PERFORMANCE SPECIFICATION SHEET

SWITCHES, THERMOSTATIC, (BIMETALLIC), TYPE I,  
HERMETICALLY SEALED, SINGLE POLE, SINGLE THROW  
(SPST), 1 AMPERE AND LOW LEVEL

This amendment forms a part of MIL-PRF-24236/13G, dated 22 January 2001, and is approved for use by all Departments and Agencies of the Department of Defense.

MIL-PRF24236/13G  
AMENDEMENT 1

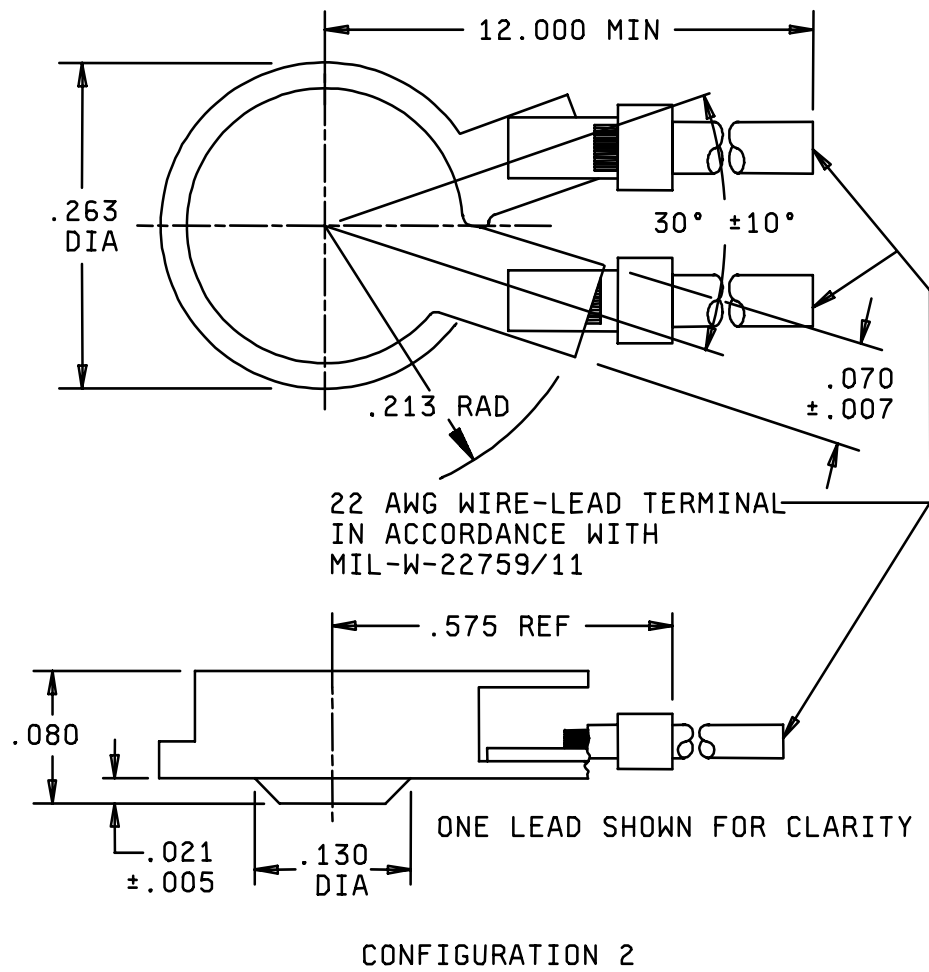
Figure 1, Delete Configuration 2 and replace with the following.
